From: Franzone, Steve [<mailto:Steve.Franzone@fpl.com>]
Sent: Monday, September 17, 2012 8:46 PM
To: Comar, Manny
Cc: Burski, Raymond; Maher, William
Subject: DRAFT RAI Responses FPL Turkey Point 6 & 7 for eRAI 6024 Basic Geologic and Seismic Information - Part 2 of 4

NRC RAI Letter No. PTN-RAI-LTR-041

SRP Section: 02.05.01 - Basic Geologic and Seismic Information

NRC RAI Number: 02.05.01-18 (eRAI 6024)

Figure 2.5.1-274 Interpreted Versions of the Southern Half of Profile FS-08 in the Straits of Florida

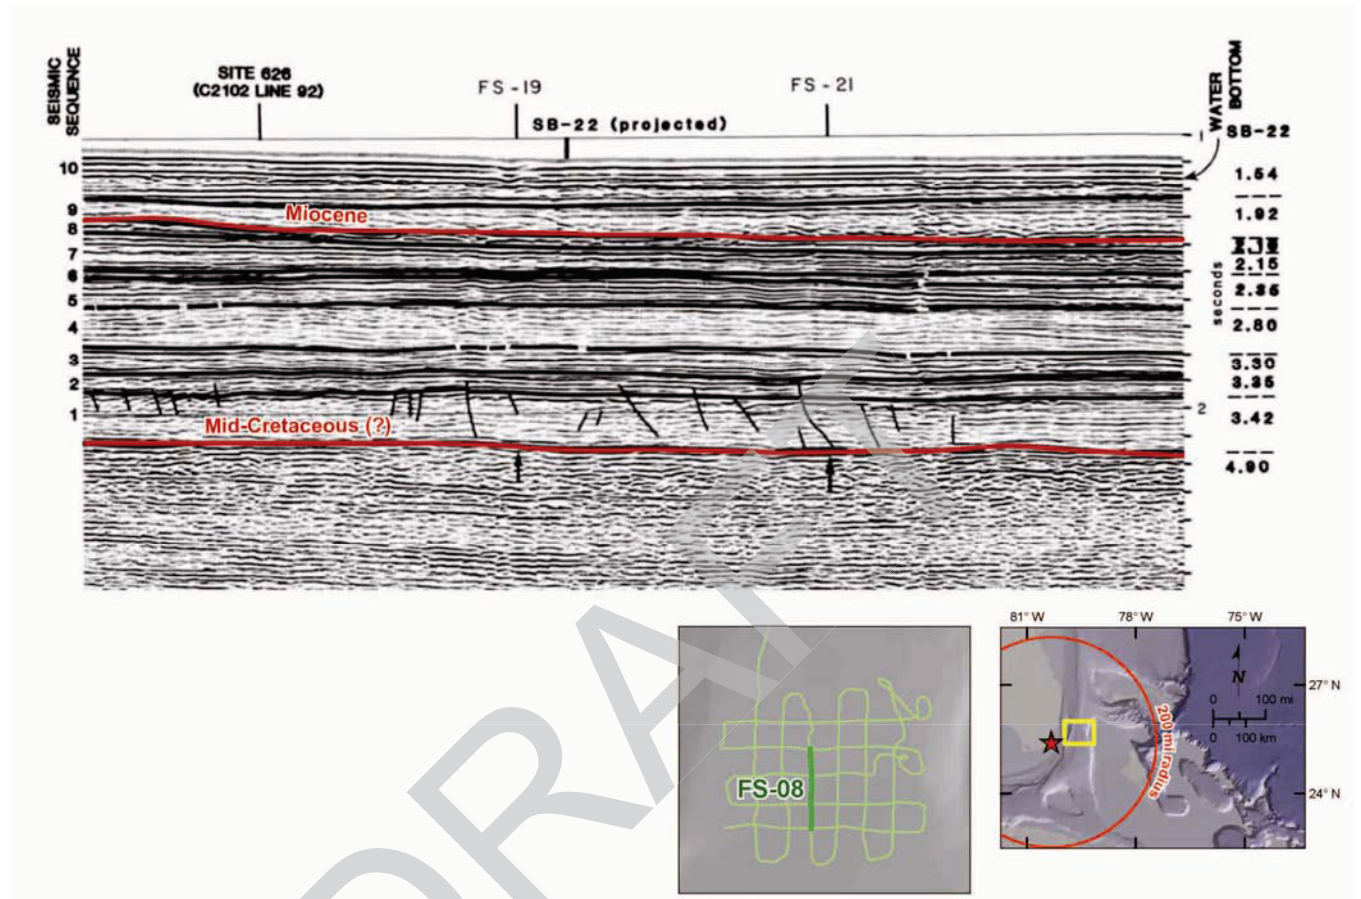
FSAR Figures 2.5.1-274 through 278 and 280, 281, and 287 shows annotated seismic sections, however the staff notes that more information is needed in order to evaluate the relative ages of deformation shown in these seismic cross sections.

In order for the staff to fully understand the regional site geology area and in support of 10 CFR 100.23, please indicate the ages and formation names, if known, of the various sedimentary strata on these figures. Please clarify what is the interpreted depth to faulted strata.

The seismic line in FSAR Figure 2.5.1-274 is from FSAR 2.5.1 Reference 785, hereafter referred to as Austin et al. (1988). Austin et al. (1988) identify 10 prominent seismic sequence boundaries above a mid-Cretaceous (?) target horizon; however, these sequences are not correlated with individual geologic formations. They interpret this target horizon as a buried shallow-water carbonate platform, with an Albian-Cenomanian (mid-Cretaceous) age. Similarly, Sheridan et al. (1981) (FSAR 2.5.1 Reference 424) hypothesize that this platform is mid-Cretaceous in age.

The only age information provided by Austin et al. (1988) for the prominent seismic sequence boundaries above the target horizon is for the 8/9 boundary (upper reflector in Figure 2.5.1-274, Figure 14 from Austin et al. (1988)), which is the only well-sampled part of the section at Site 626. They correlate the debris flows and turbidites sampled there with the Great Abaco Member of the Blake Ridge Formation, which would mean sequence 9 is composed of middle Miocene deposits. Austin et al. (1988) note that consistent fault offset is only seen at the sequence 1/2 boundary. One of these faults is interpreted to almost reach the 2/3 boundary, which lies at a depth of 1.74 kilometers (1.08 miles) beneath sea

level and roughly 940 meters (3080 feet) beneath the seafloor (assuming a mean water depth of 800 meters (2620 feet), see Table 5 and Figure 13 from Austin et al. 1988). This faulting occurred between the deposition of mid-Cretaceous and middle Miocene sequences.

Figure 2.5.1-342 Isopach of the Site: Key Largo Limestone

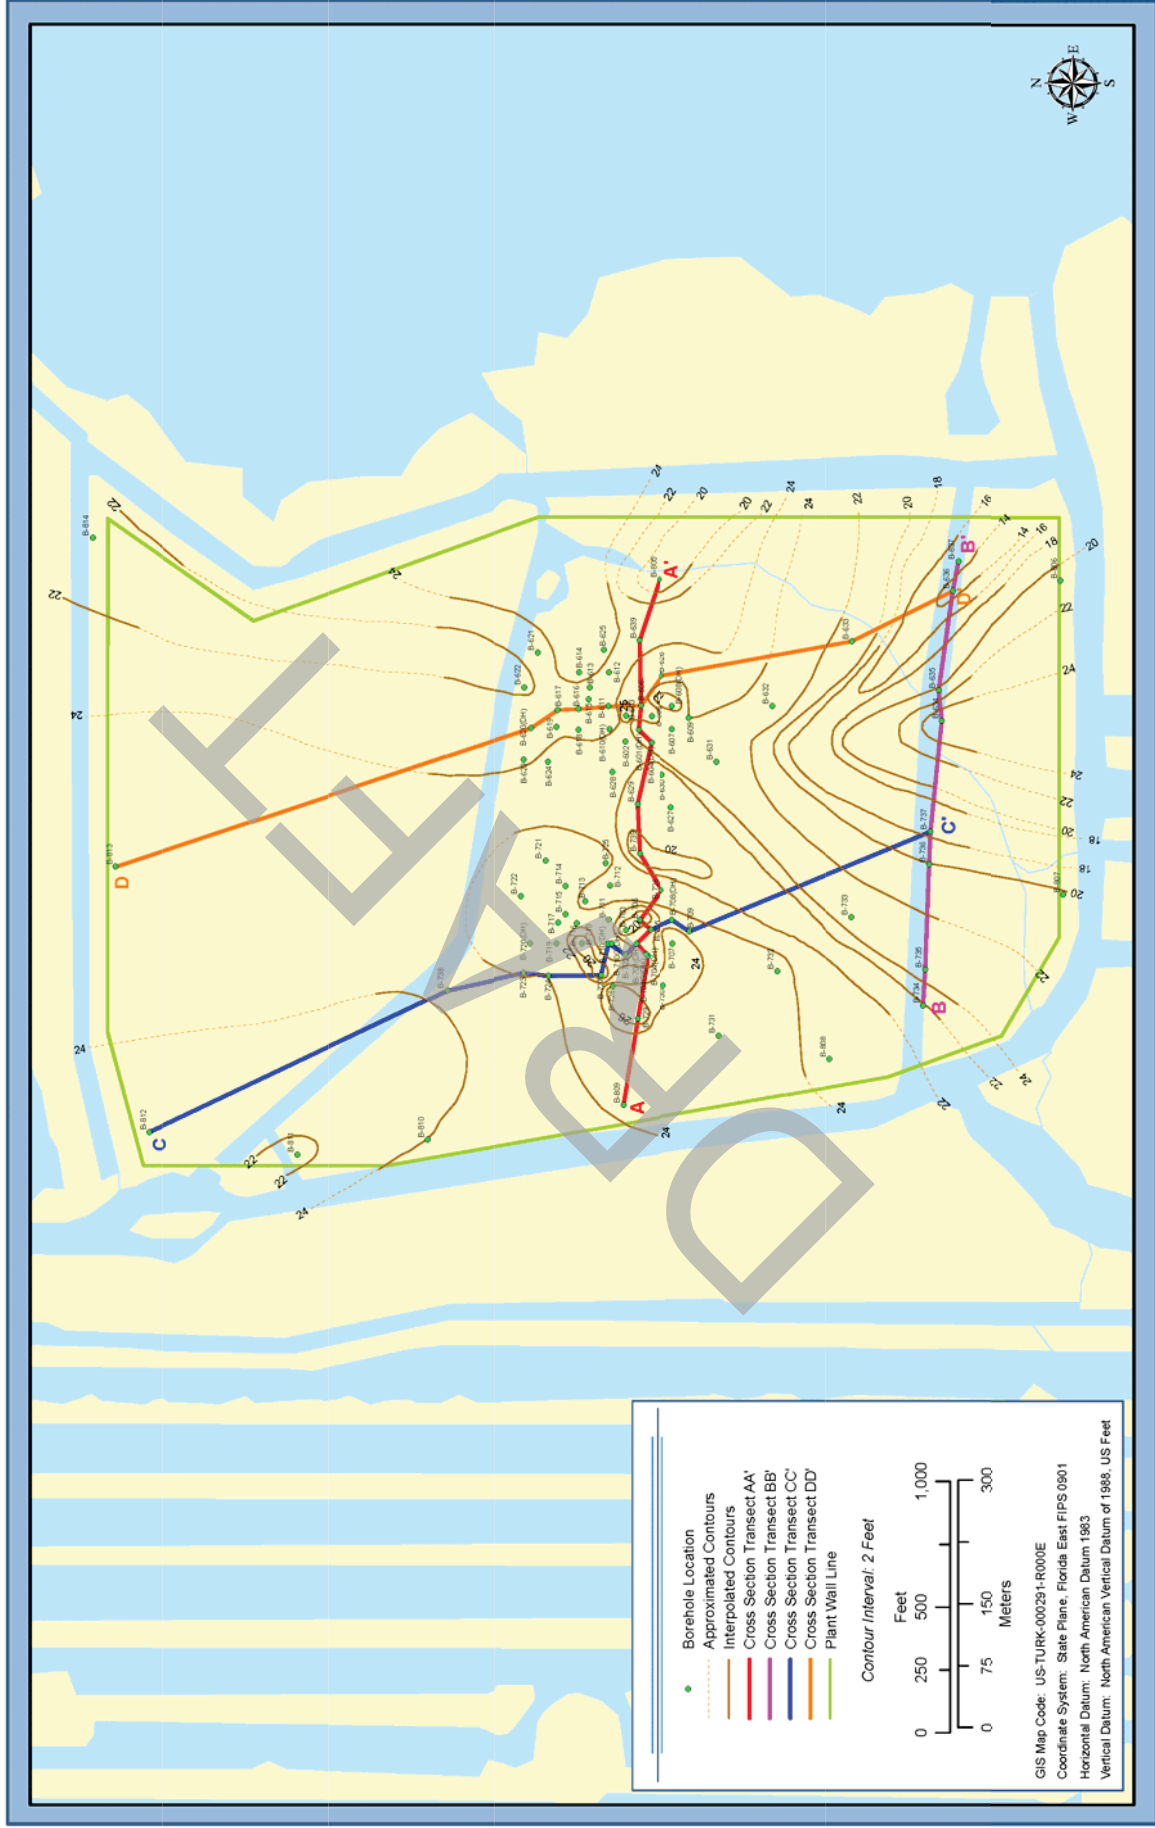
FSAR Figures 2.5.1-342, -343, and -344 illustrate isopach and structure contour maps of the Key Largo Limestone and Fort Thompson Limestone stratigraphic units. The staff notes, however, that additional information is needed on the maps to understand the nature of the Key Largo and Fort Thompson limestone units.

- a) Indicate the elevation on the structure contour maps and thickness values on the isopachs.
- b) Indicate thin areas on the isopachs and low areas on structure contours.
- c) Plot the location of cross section lines A, B, C, and D on the isopach and structure contour maps.
- d) Provide a structure contour for the Key Largo formation.
- e) The FSAR describes the Fort Thompson Formation as vuggy, and solution-riddled. In light of this characteristic in the underlying Fort Thompson, discuss the implication of the numerous closed circles shown on the Key Largo isopach.

The updated Figures 2.5.1-342, 343, and 344 and Figure 1 are provided on pages 5 through 8 of this response. Upon review of Figures 2.5.1-342, 343, and 344, it was discovered that the FSAR Figure 2.5.1-342 "Isopach of the Site: Key Largo Limestone" actually depicted the "Structure Contour Map: Top of Key Largo Limestone". As part of this response the correct figure for "Isopach of the Site: Key Largo Limestone" is provided in the Associated COLA Revisions. Figure 1, "Structure Contour Map: Top of Key Largo Limestone", is updated and will be added in a future revision of the FSAR as "Figure 2.5.1-349 Structure Contour Map: Top of Key Largo Limestone".

- a) The updated elevation values on the structure contour maps and updated thickness values on the isopach maps for the respective Figures 2.5.1-342, 343, and 344 and Figure 1 are provided on pages 5 through 8 of this response.
- b) As shown on the updated Figure 2.5.1-342, the thickness of the Key Largo Formation ranges from about 15 to 30 feet with a minimum thickness of about 15 feet. As shown on Figure 2.5.1-344, the thickness of the Fort Thompson Formation ranges from about 60 to 70 feet.

c) The location of cross section lines A, B, C, and D are plotted on the updated Figures 2.5.1-342, 343, and 344 and Figure 1.

d) The updated structure contour map for the Key Largo Formation is provided in this response as Figure 1 and will be a new figure, Figure 2.5.1-349, in a future revision of the FSAR. The updated isopach map for the Key Largo Formation is provided as FSAR Figure 2.5.1-342.

Figure 1. Figure 5 from Cunningham et al (1998); Stratigraphic correlation diagram across southern Florida.

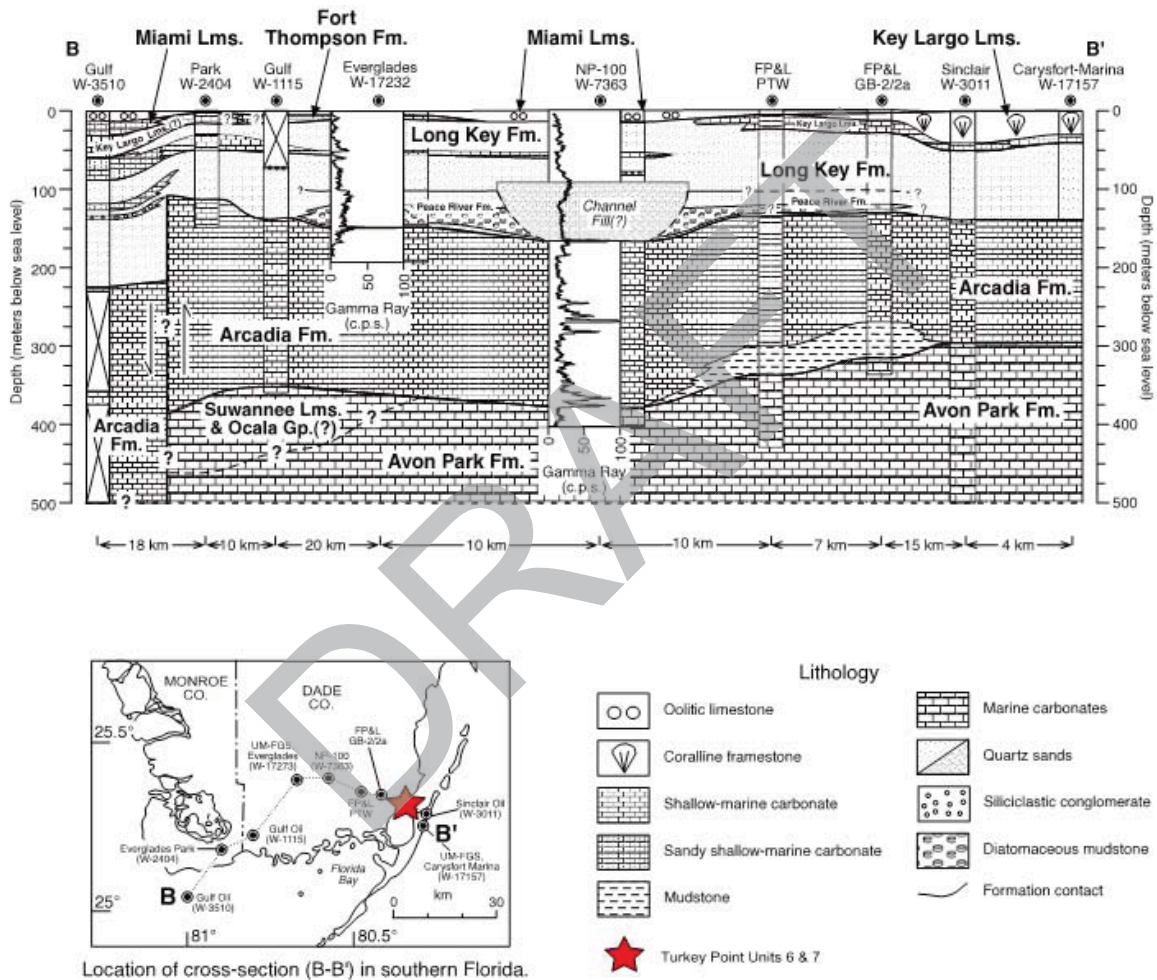
- a) Substantiate your interpretation with specific evidence that the stratigraphic relations across the queried fault shown in Figure 2.5.1-234 and depicted in Reference 373 are a result of paleo-topographic or karst processes, rather than tectonic offset.
- b) If the queried fault is indeed a fault, please discuss the timing and spatial extent of faulting and update the FSAR discussion accordingly.

Figure 1 is a modified version of FSAR Figure 2.5.1-234 that shows a cross-section across southern Florida (Figure 5 of Cunningham et al. [1998]). This cross-section was developed with data from eight wells in southern Florida. Between the southernmost two wells, Cunningham et al. (1998) postulate the existence of a fault that cuts up through Avon Park Formation, Suwannee Limestone, and Oligocene-Miocene-age Arcadia Formation, and potentially places the Arcadia Formation in fault contact with the lower portion of the overlying Miocene-Pliocene Long Key Formation. Alternatively, the Long Key Formation may be interpreted as deposited across a paleoscarp. Cunningham et al. (1998) label the postulated fault on this cross-section with two question marks, indicating the speculative nature of this fault. It should also be noted that Figure 1 includes a

variable horizontal scale, which necessarily results in variable vertical exaggeration throughout the cross section. Some of the greatest vertical exaggeration is in the vicinity of the postulated fault.

The queried fault on Cunningham et al.’s (1998) Figure 5 (FSAR Figure 2.5.1-234) is drawn to explain thickness and stratigraphic variations. These variations may instead be related to paleotopography, indeed, the top of the Arcadia Formation is known to have significant paleotopographic variation. On Key Largo, relief on the top of the Arcadia Formation as large as 40 meters was found between borings only a few kilometers apart (Warzeski et al., 1996). Furthermore, in Cunningham et al.’s (1998) Figure 4 (Figure 4), the elevation of the top of the Arcadia Formation varies by approximately 100 meters between wells W-3174 and W-17086 (88 km apart), by 50 meters between wells W-17156 and W12554 (56 km apart), and by 25 m between wells W-3011 and W-17157 (2 km apart). The slope required to achieve this latter elevation variation, 0.7 degrees, is actually greater than the slope required to achieve the elevation variation observed in the Arcadia Formation between the Everglades Park and Gulf Oil wells, where the queried fault is depicted in Figure 5 of Cunningham et al. (1998) (approximately 100 meters over 18 kilometers of distance, or a 0.3 degree slope). Numerous other examples exist throughout southern Florida of steeper paleotopographic slopes on the top of the Arcadia Formation that are not associated with faulting. In addition, the down-to-the-south separation depicted on the postulated fault in Figure 1 is consistent with, and may, in part, be attributed to the regional southward dip of the strata towards the South Florida Basin in the area (e.g., Miller, 1986; Figure 6). Similarly, the increase in the thickness of clastics south of the fault is consistent with thickness variations seen throughout southern Florida associated with proximity to the “coarse sand channel” (Figure 2).
